UNITED STATES PATENT AND TRADEMARK OFFICE

APPLICATION NO.	FILING DATE	FIRST NAMED INVENTOR	ATTORNEY DOCKET NO.	CONFIRMATION NO.
10/709,715	05/24/2004	Kuo-Hsing Cheng	11586-US-PA	3714

Office Action Summary	Application No. 10/709,715	Applicant(s) CHENG, KUO-HSING	
	Examiner Seokyun Moon	Art Unit 2629

DETAILED ACTION

Drawing 1

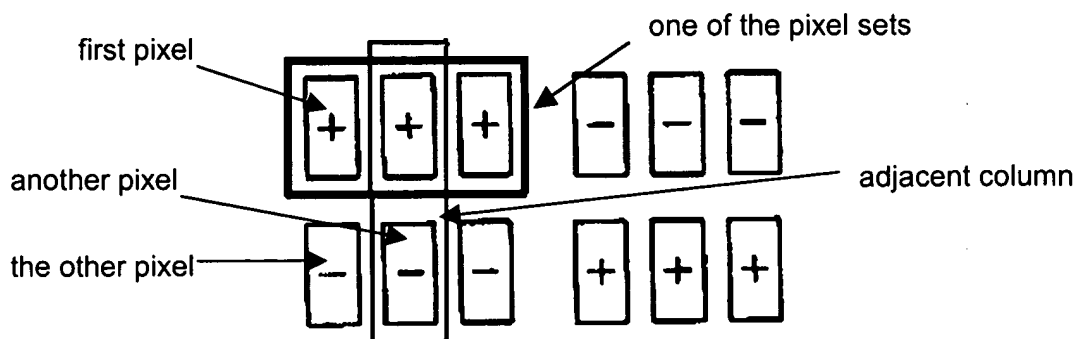
As to **claim 1**, Kim teaches [fig. 6a] [par. (0052)] a driving method (providing a voltage with a specific polarity to each of a plurality of pixel sets) for a pixel array, at least one row of the pixel array comprising a plurality of pixel sets ("*pixel groups*"), and at least one of the pixel sets comprising a plurality of pixels ("*three pixels*"), the driving method comprising:

providing a plurality of voltages having substantially same phase to a plurality of pixel electrodes of the pixels of one of the pixel sets [drawing 1 provided on page 4 of this office action, which is equivalent to fig. 6a of Kim];

providing at least two voltages with phases substantially opposite to each other to the pixel electrodes of the pixels of two of the adjacent pixel sets respectively [drawing 1 provided above];

As to **claim 2**, Kim teaches each of the pixel sets comprising three pixels [drawing 1 provided above].

As to **claim 3**, Kim teaches that a number of the pixels of each of the pixel set is $3 \cdot M$, where M is a positive integer [drawing 1 of this office action].

Drawing 2

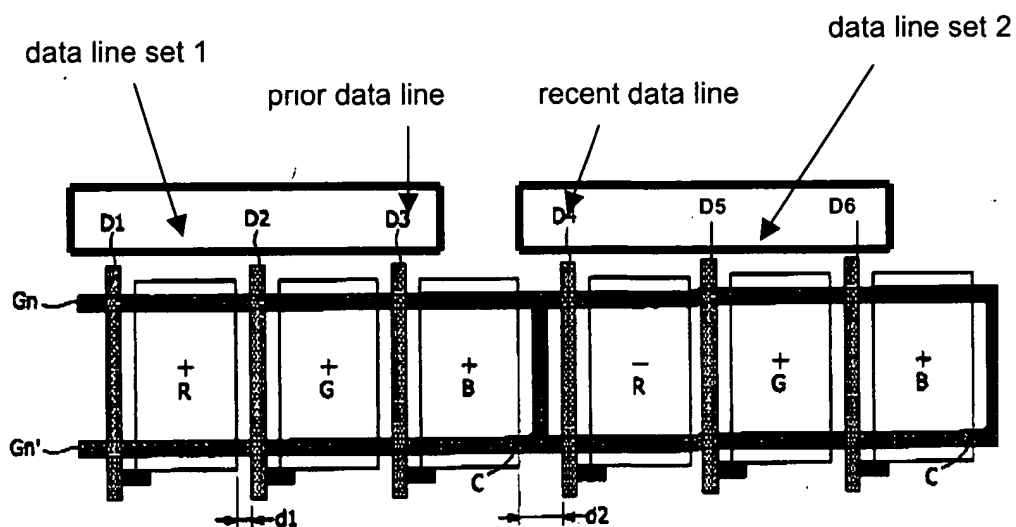
driving a first pixel in one of the pixel sets and another pixel in an adjacent column of the first pixel by another gate line, wherein a phase of a voltage of a pixel electrode of the first pixel and a phase of a voltage of a pixel electrode of the another pixel are substantially different, and the first pixel and the another pixel are respectively in different rows of the pixel array [drawing 2 provided below, which is equivalent to fig. 6a of Kim]

As to **claim 4**, Kim teaches the other pixel being disposed in an adjacent row of the first pixel [drawing 2 provided on page 4 of this office action].

Drawing 3

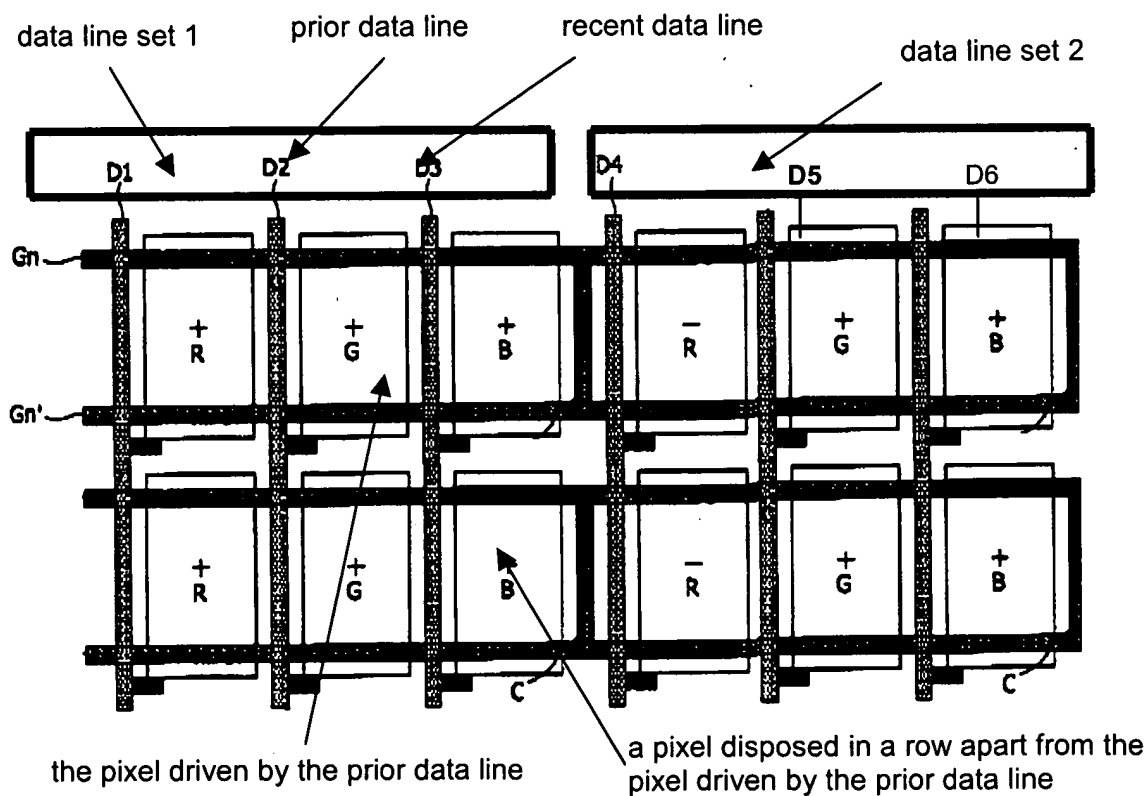
As to **claim 5**, Kim [fig. 6a] [par. (0052)] teaches a driving method (providing a voltage with a specific polarity to each of a plurality of pixel sets) for a pixel array, each row of the pixel array comprising at least one pixel set, at least one of the pixel set comprising a plurality of pixels, and each pixel set corresponding to a data line set, the driving method comprising:

when the prior data lines and the recent data line do not belong to same data line set, the recent data line is used to drive the pixel disposed after the pixel driven by the prior data line [drawing 3 provided on page 6 of this office action, which is equivalent to figs. 6a and 10]; and

when the prior data line and the recent data line belong to same data line set, the recent data line is used to drive one of a pixel disposed in a row apart from the pixel driven by the prior data line [drawing 4 provided on page 6 of this office action, which is equivalent to figs. 6a and 10].

Kim inherently teaches a method of determining whether a prior data line and a recent data line belong to same data line set or not since it is required for the display of Kim to provide voltages having different polarities to each of different data line sets.
